ADDENDUM 1 TO ENVIRONMENTAL IMPACT REPORT

Date of Publication of Addendum: October 10, 2024
Date of EIR Certification: September 5, 2019
EIR Case No. **2015-014028ENV**
Project Title: **3333 California Street Mixed-Use Project**
Modified Project Case No.: **2015-014028ENV-02**
Block/Lot: 1032/003
Project Sponsor: Don Bragg, Laurel Heights Partners, LLC
(415) 857-9324
Lead Agency: San Francisco Planning Department
Staff Contact: Debra Dwyer – (628) 652-7576
debra.dwyer@sfgov.org

Figure 4a. Proposed Site Access – Modified Project

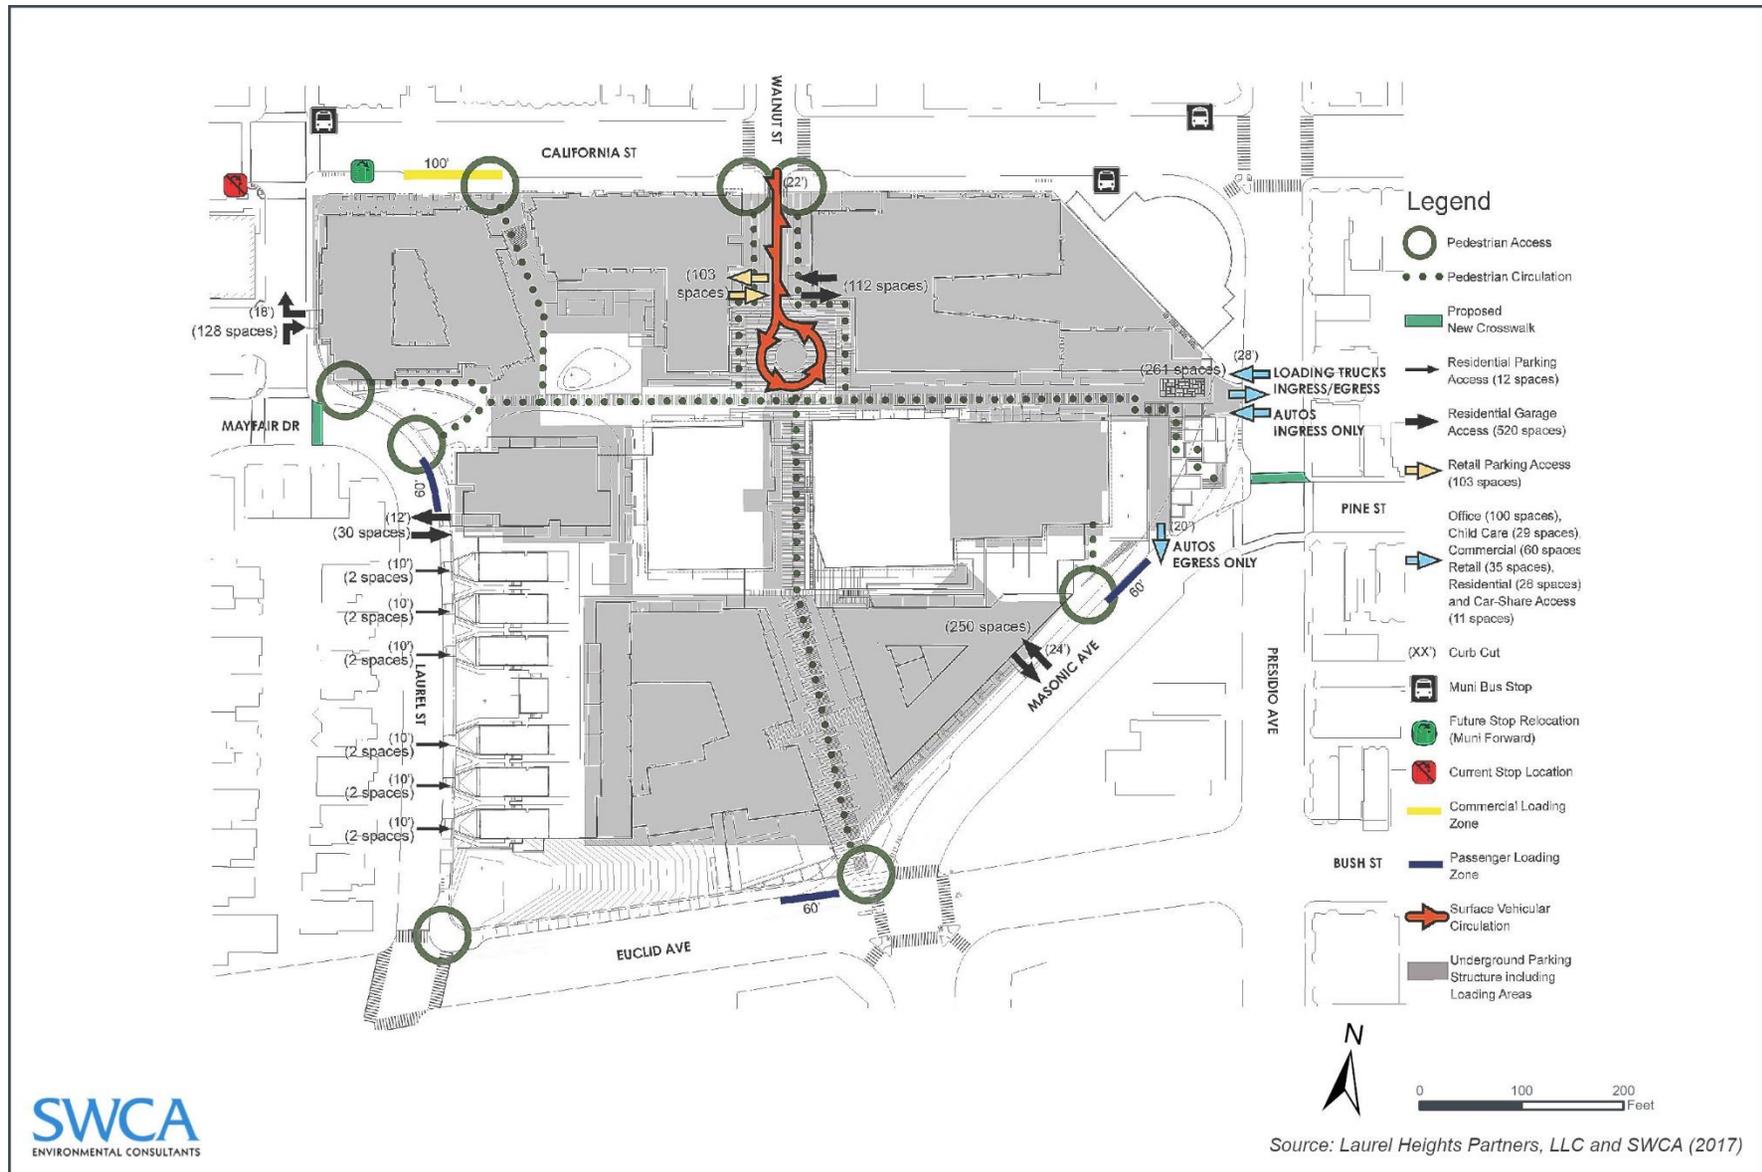
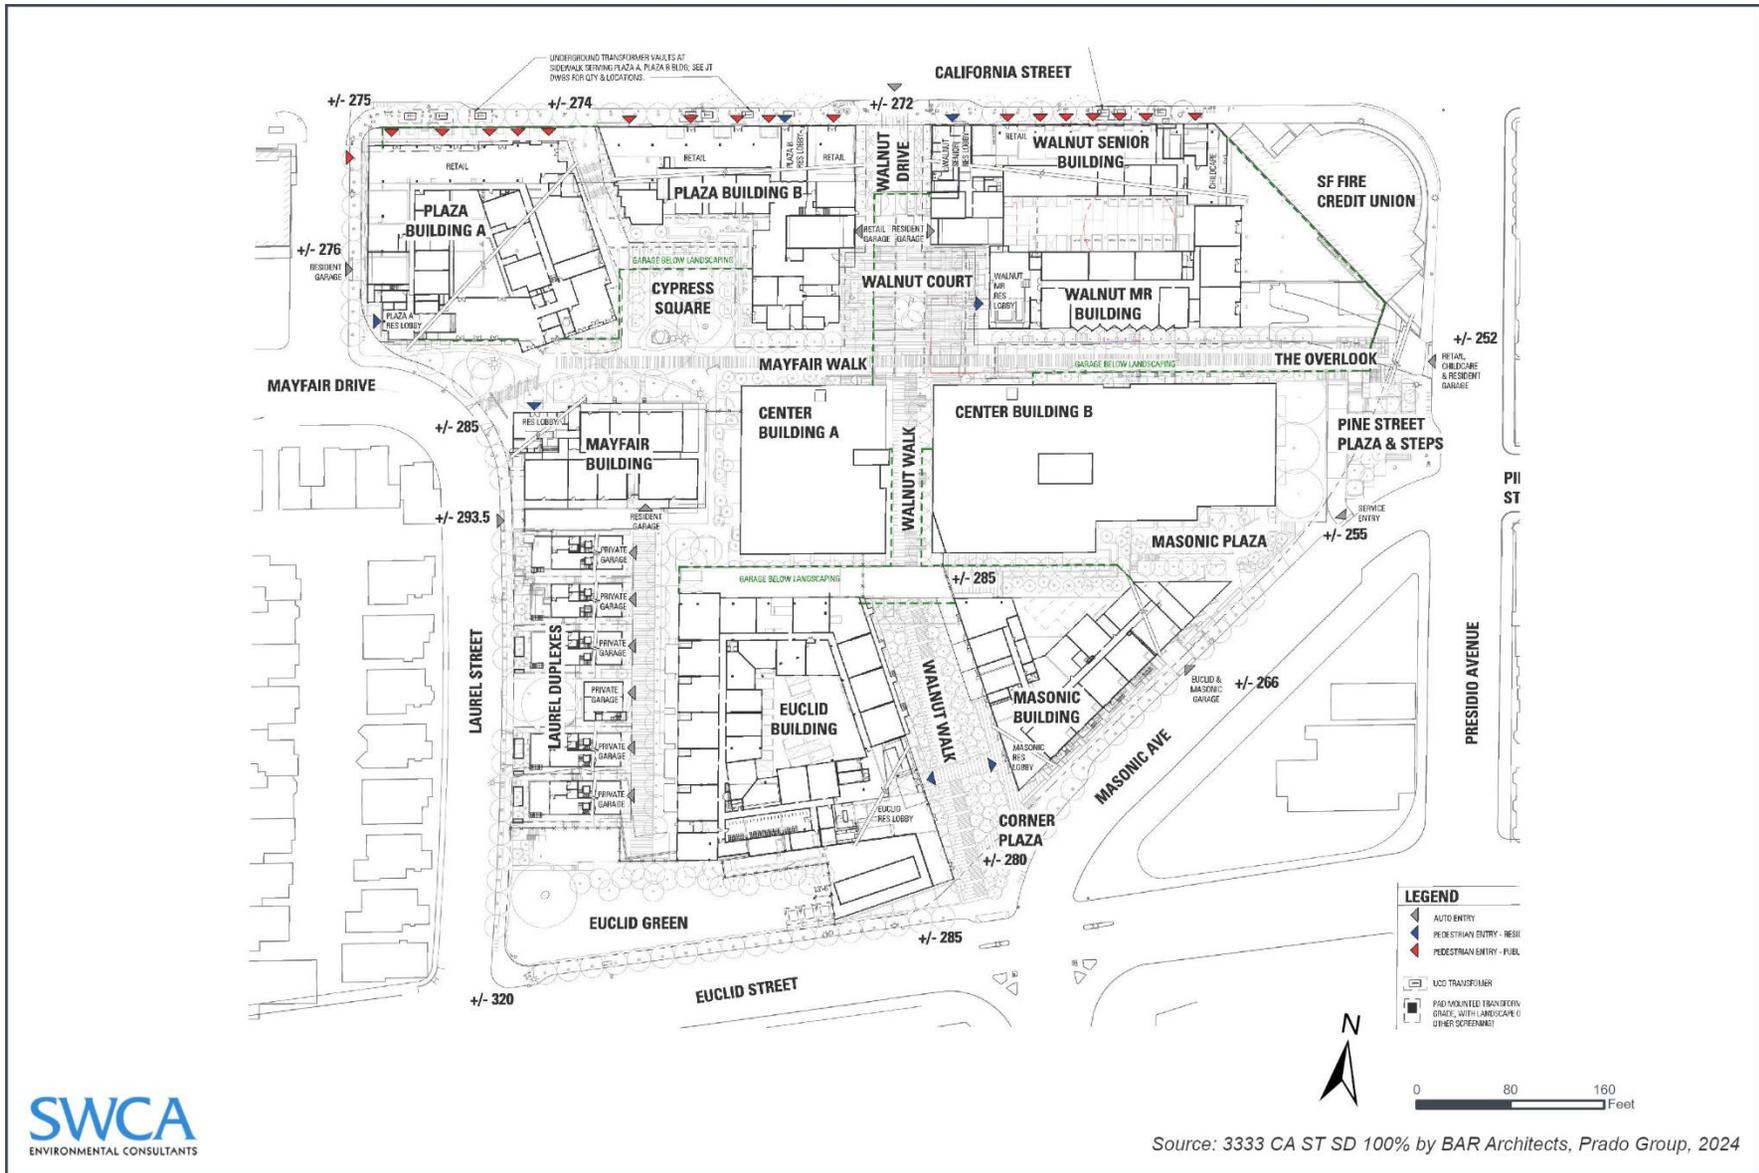
Under the modified project, the proposed off-street parking garage layouts for the California Street, Masonic Avenue, and Laurel Street/Mayfair Drive garages would be slightly different than those assumed for the approved project. Under the modified project on-street commercial and passenger loading zone locations and widths would be essentially the same as the approved project as would the curb cuts and

driveway locations for entry and exit to the off-street garages (see **Figure 3: Proposed Site Access - Approved Project**, p. 13, **Figure 4a: Proposed Site Access - Modified Project**, p. 14, and **Figure 4b: Proposed Site Access - Modified Project**, p. 15).

Figure 6. Preliminary Construction Phasing Diagram - Modified Project

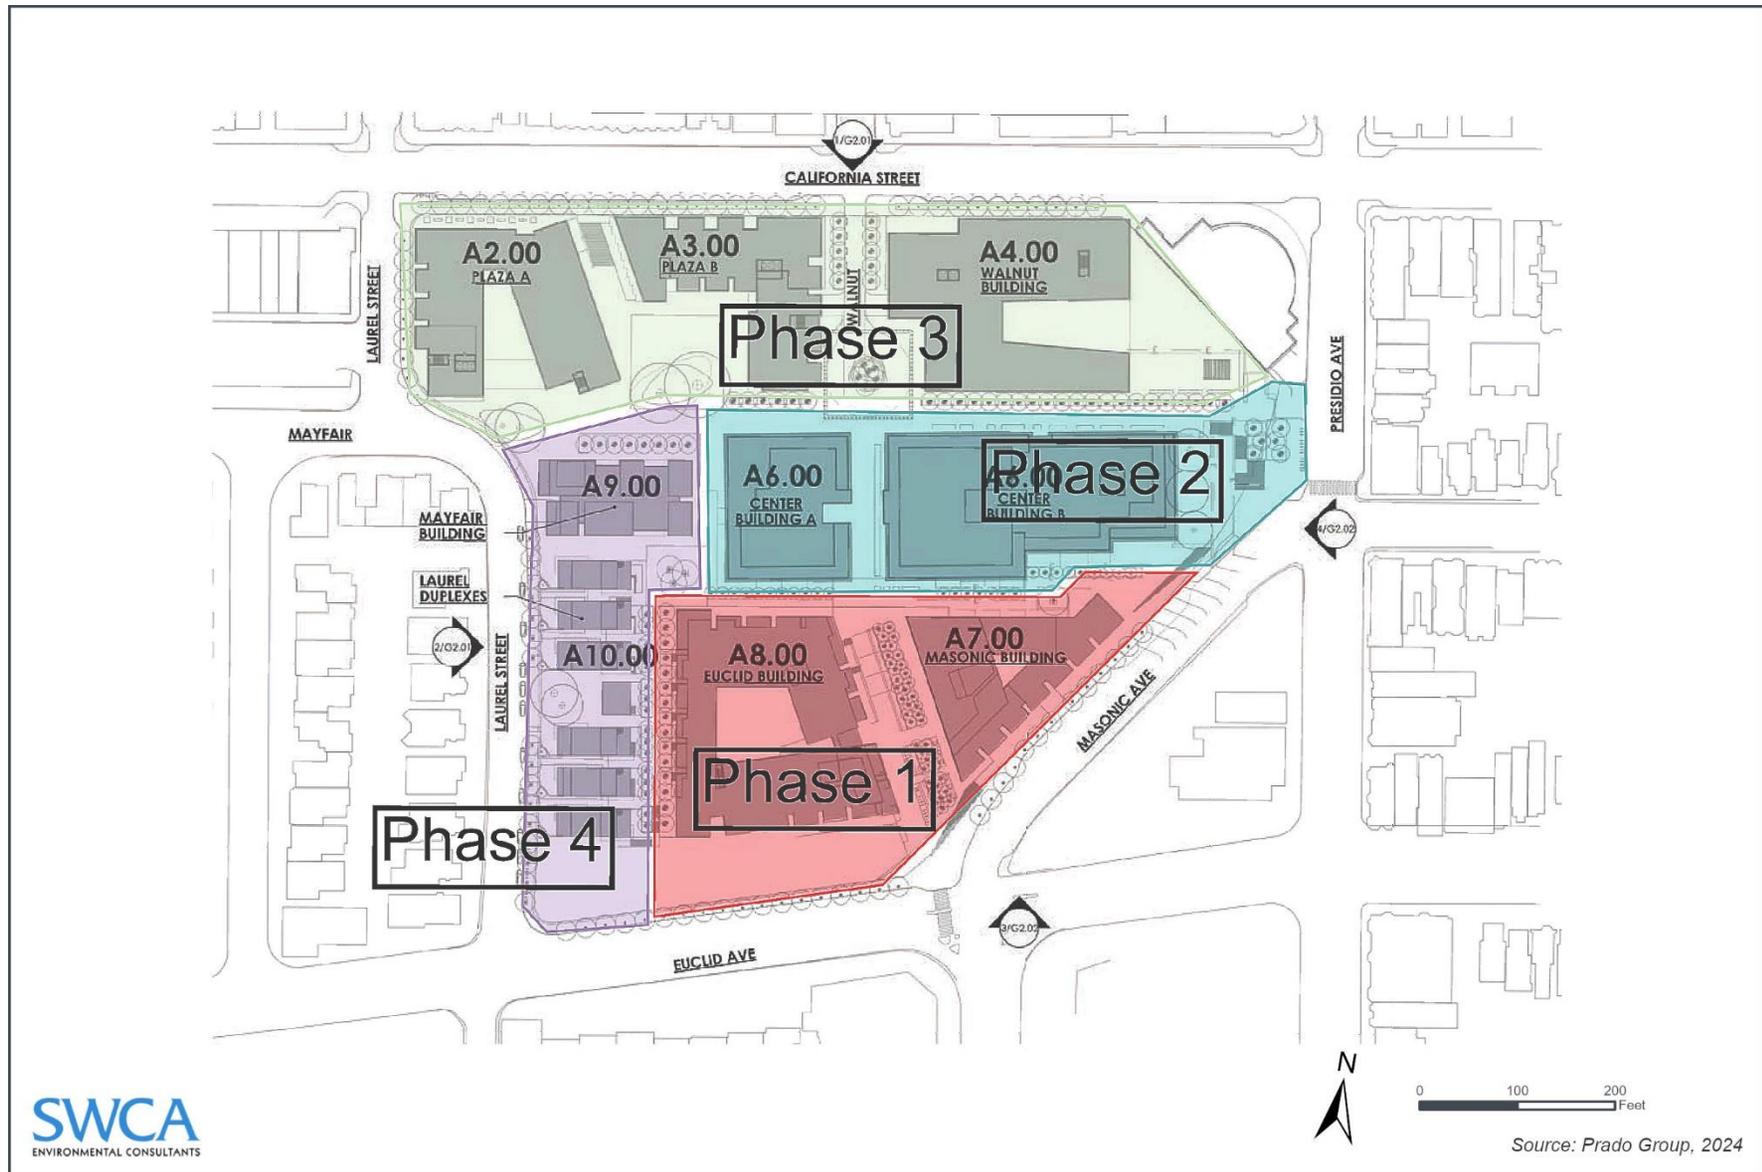
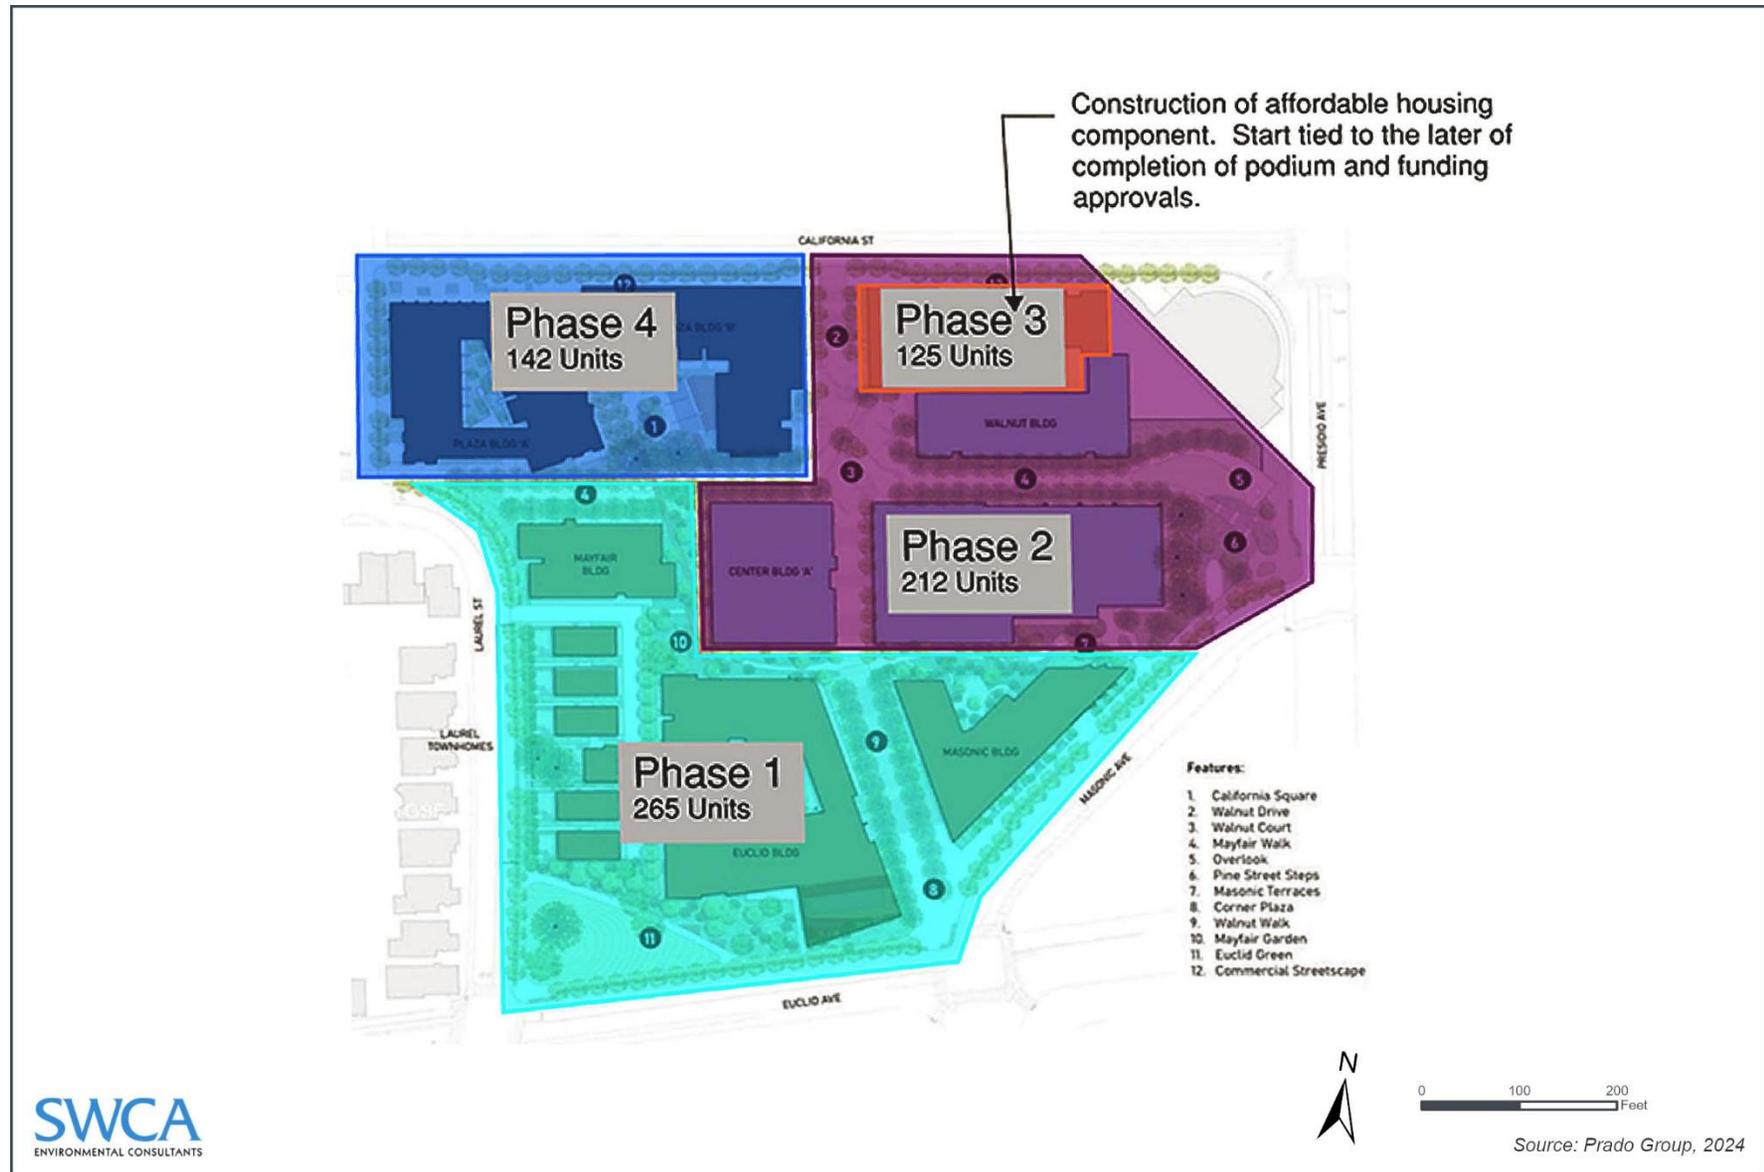
Full-build out under the modified project would be expected in five years, rather than in seven years as described and analyzed in the EIR for the most conservative CEQA analysis. As shown in **Table 3**, p. 9, the preliminary construction schedule under the modified project assumes spring 2025 as the start of construction and spring 2030 as the end of construction. As shown in **Figure 5: Preliminary Construction Phasing Diagram - Approved Project** and **Figure 6: Preliminary Construction Phasing Diagram - Modified Project**, pp. 16 and 17, construction activities for the four development phases would be modified to develop a larger proportion of the residential component of the overall development program more expeditiously (i.e., more housing units earlier). Like the approved project the proposed development program would also be constructed over four overlapping construction phases but with minor modifications. Site redevelopment under the modified project is listed below Mayfair Building and Laurel Duplexes with Phase 1, as modified, rather than Phase 4, as approved; and Walnut Building (the market rate component) with Phase 2, as modified, rather than Phase 3, as approved.

- Phase 1 (Masonic, Euclid, and Mayfair buildings and Laurel Duplexes)
- Phase 2 (Center Building A, Center Building B, and new Walnut Building)
- Phase 3 (Senior Affordable Housing)
- Phase 4 (Plaza A and Plaza B Buildings)

For the modified project, construction would continue to be sequenced over four development phases but would be developed over five years rather than seven years for the approved project (see **Table 3**, **Figure 5**, and **Figure 6**, pp. 9, 16 and 17, respectively). Further changes would include a slight re-ordering of the components of each of the four development phases, i.e. the Laurel Duplexes and Mayfair Building would shift from Phase 4 under approved project to Phase 1 under modified project. There would be limited changes to the site preparation, demolition, and excavation program. Most other important project features such as number and location of emergency diesel generators and equipment associated with heating ventilation air conditioning (HVAC) systems would also be essentially the same although in slightly different locations due to level-by-level and floor-by-floor refinements to the residential, retail, and childcare uses and to off-street parking layouts. The *2024 Updated Phasing Project Air Quality and Noise Analysis Results* are available for review.⁷
